Subject: San Jacinto River Waste Pits Superfund Site – Final Comments on Draft Feasibility Study

Thank you for asking the Technical Review Team of Harris County (“Technical Review Team”) to review and provide comments on the Draft Feasibility Study (“Draft FS”) prepared by responsible parties McGinnes Industrial Maintenance Corporation and International Paper Company and their consultant Anchor QEA in connection with the San Jacinto River Waste Pits Superfund Site (“SJRW” or “Site”).

Figure 10  
 Relationships between Blue Crab Tissue and Surface  
 Sediment Concentrations of 2,3,7,8-TCDF (ng/kg, ND=½DL)  
 Bioaccumulation Technical Memo  
 SJRWP Superfund/MIMC and IPC

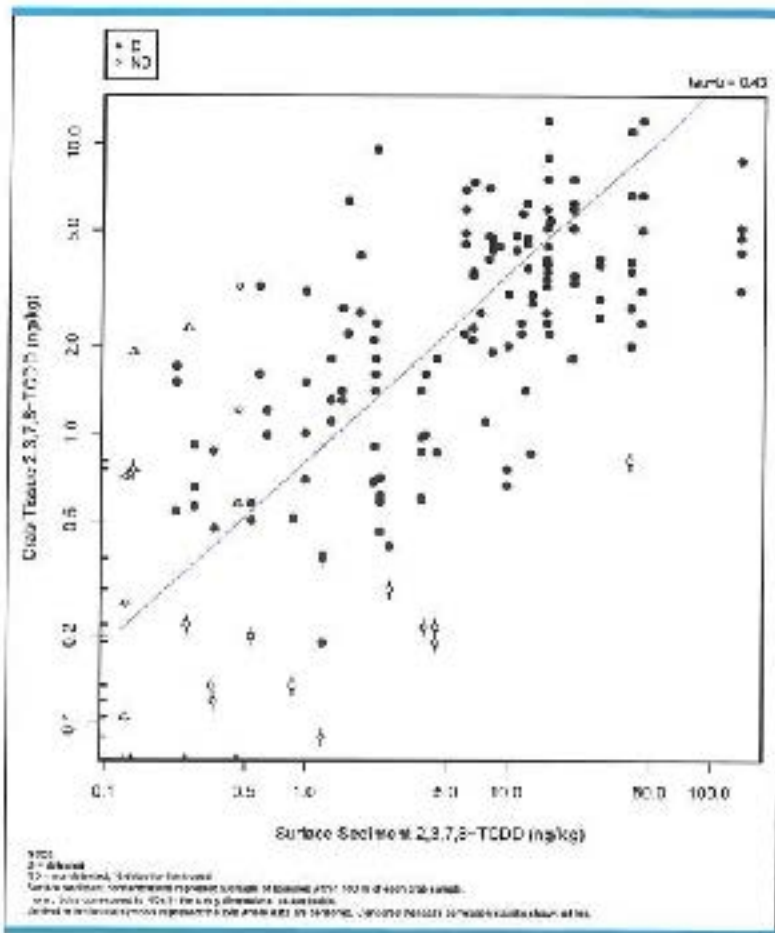
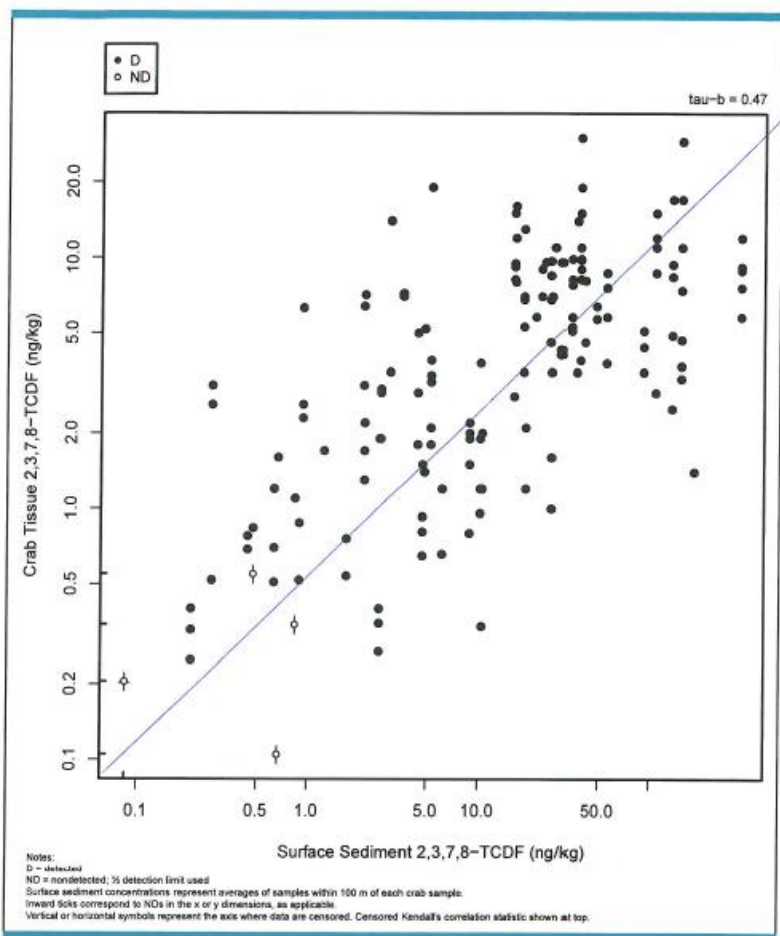
- 7) Section 2.5.5.1, Bioaccumulation, Page 17. States “bioaccumulation of PCDD/Fs cannot be understood on the basis of aggregate quantities, such as TEQ concentrations.” “the majority of dioxin and furan congeners do not consistently bioaccumulate in fish or vertebrate tissue. ...As a result, systematic predictions of bioaccumulation from concentrations of dioxins and furans in abiotic media (both sediment and water) are only possible for tetrachlorinated congeners. However, even these correlations are weak, and are associated with high uncertainty.”

We concur that bioaccumulation varies by congener, for reasons that are thoroughly described in the technical memo, and that bioaccumulation of the more chlorinated PCDD/Fs is limited. This has been previously reported by the UH/Parsons team in their numerous reports to the TCEQ TMDL program as well as their scientific publications (Dean et al. (2009); Dean et al. (2003); Suarez et al. (2005)). However, it is important to keep in mind that the PCDD/F risk from fish consumption is primarily due to 2378-TCDD and 2378-TCDF. While some of the larger congeners are relatively abundant by mass in fish and shellfish tissue, 2378-TCDD and 2378-TCDF are on average responsible for more than 80% of the risk-normalized concentration (expressed as TEQ) in fish and crabs, as shown in the table below. In fact, more than 80% of the TEQ in fish and 60% of the TEQ in crabs was from 2378-TCDD alone. Thus, the aggregate quantity, TEQ, primarily reflects 2378-TCDD. As the references cited in the bioaccumulation technical memorandum show, 2378-TCDD and 2378-TCDF are substantially bioaccumulated in crabs, and 2378-TCDD is bioaccumulated in catfish, in a manner and degree not unlike most other hydrophobic organic compounds. Moreover, their concentrations in fish and shellfish are roughly proportional to concentrations in sediment, implying that application of a Biota Sediment Accumulation Factor (BSAF) is appropriate to predict bioaccumulation from concentrations in sediment. This is illustrated in Figures 3 and 10 of the bioaccumulation memo, reproduced below. We do not consider these correlations to be particularly weak for a natural system, particularly after considering that fish and crabs are mobile organisms and likely to be exposed to a range of contaminant concentrations, even considering high site fidelity. Also, the variability in these BSAFs can be reduced by utilizing the typical form of the BSAF, the ratio of lipid normalized tissue concentrations to organic carbon – normalized sediment concentrations, and computing BSAFs by the method of Burkhard (2009). Moreover, we believe that the uncertainty in BSAF should not preclude its use in developing appropriate PCLs. We believe that bioaccumulation of PCDD/Fs can be understood based on TEQ due to its dominance by 2378-TCDD, though we concur that it is best to consider the bioaccumulation potential of each congener individually.

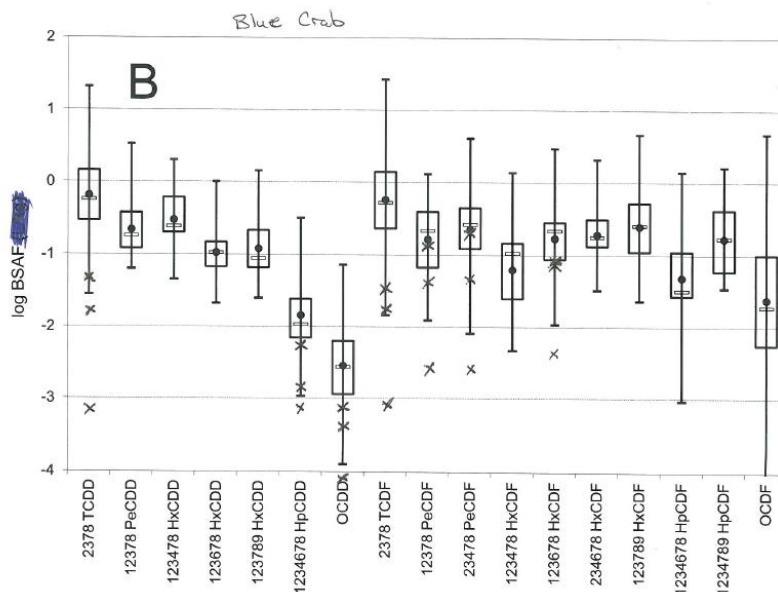
The BSAFs reported for blue crab in the RI are anomalously low relative to those reported by the UH/Parsons Team. In the figure below, the BSAFs reported for the three fish collection areas by congener are displayed with an “x” superimposed on box plots developed from data reported by UH/Parsons, which involved co-located sediment and crab samples from dozens of sampling stations throughout the Houston Ship Channel (HSC) and Galveston Bay system over several years. In many cases, the BSAFs reported are lower than any of the more than 100 values measured by UH/Parsons. This might be expected to result from a combination of high localized sediment PCDD/F concentrations in the Preliminary Site Perimeter (which constitute the denominator of the BSAF) with mobile organisms (crabs) that are exposed over their travels to less contaminated sites (and thus a lower BSAF numerator). However, the sediment PCDD/F concentrations utilized in the RI BSAF calculation are approximately equal to the average sediment concentration from the entire system reported by UH/Parsons, and the source of the low BSAF was instead found to be anomalously low levels reported in crabs from the site. The reported levels in crab are anomalously low even when compared to samples collected within the Preliminary Site Perimeter reported by UH/Parsons. We recommend that the source of this discrepancy be further investigated, as it represents one of the major PCDD/F exposure routes to humans. It may be due to differences in the size/age of the crabs collected, or judgments on what portion of the edible meat was extracted from the carapace for analysis. This discrepancy was not observed for catfish tissue.

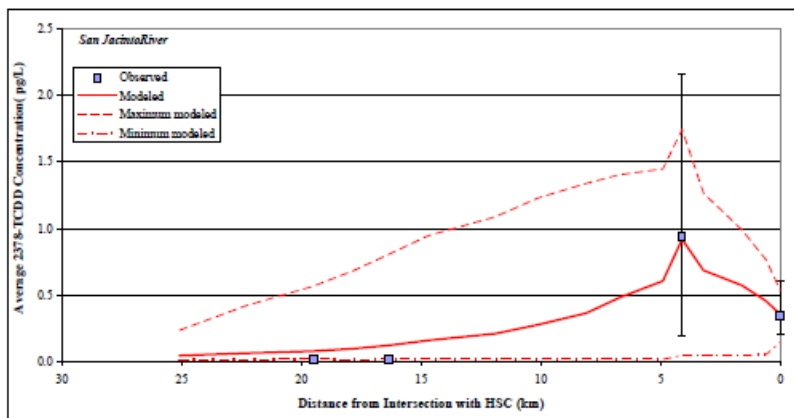
- 30) Section 1.1.3 of Appendix A, page 6, first paragraph indicated that “the chemical fate model predicted a decline in surface sediment concentrations within the area surrounding the USEPA’s Preliminary Site Perimeter over the period from 2005- to 2010 that is within a factor of 2.5 of the decline estimated from data-based evaluations [...]” Samples collected between 2002 and 2011 in the San Jacinto River for water column, fish tissue, and sediment do not support the conclusion that there have been declines of dioxin concentrations (see Figure 6, Attachment 2).

(b) Feasibility Study Model of TCDD in the San Jacinto River

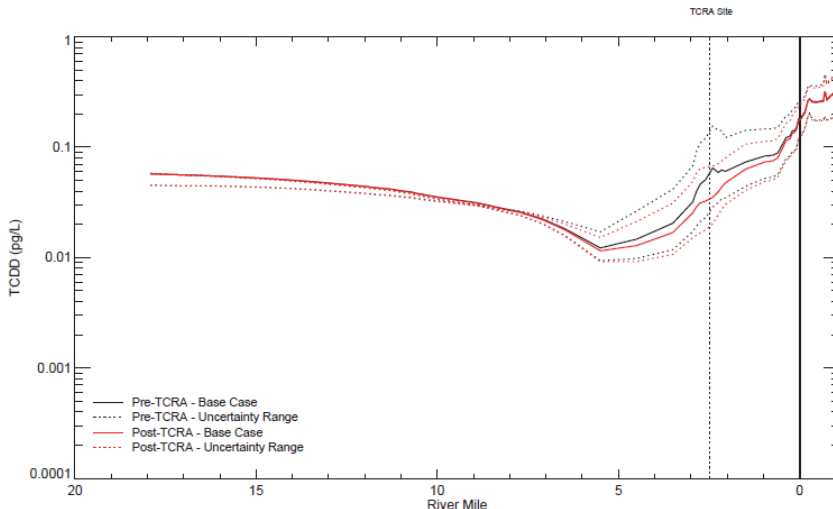
32) Section 3.2.2.1 of Appendix A, In Figure 3-14, the chemical fate and transport model for base case conditions shows water column concentrations of TCDD declining from approximately 0.06 pg/L at the upstream boundary below Lake Houston down to nearly 0.01 pg/L at river mile 5 upstream of the TCRA site, before rising to approximately 0.07 pg/L at the TCRA site, then rising further to approximately 0.2 pg/L at the lower boundary near the confluence with Buffalo Bayou. Neither these levels nor the pattern are supported by data collected by the TCEQ TMDL effort, even considering the model uncertainty bounds. The TCEQ TMDL data, measured between 2002 and 2012 using high-volume sampling for low detection levels, showed TCDD concentrations of no more than 0.1 pg/L upstream of the TCRA site, rising sharply to approximately 1 pg/L at the I-10 bridge near the TCRA (0.23 – 2.16 pg/L, average = 1.07 pg/L, n=6), then falling to an average 0.4 pg/L at the confluence with Buffalo Bayou. For comparison purposes, the model outputs of the TMDL model (a) and Feasibility Study model (b) are reproduced below. Because model predictions do not appear to overlap with observations, even after considering model uncertainty, we are concerned that the model does not accurately simulate sources of TCDD and processes controlling TCDD concentrations. It does appear to be a reliable management tool for evaluating remedial alternatives. Additionally, because the simulated concentrations underestimate water concentrations, we believe the remediation scenarios show a much greater impact on dioxin levels in the water column than could be expected. If the initial levels are high (as supported by the sampling data), then the remediation will not affect the overall concentrations significantly.
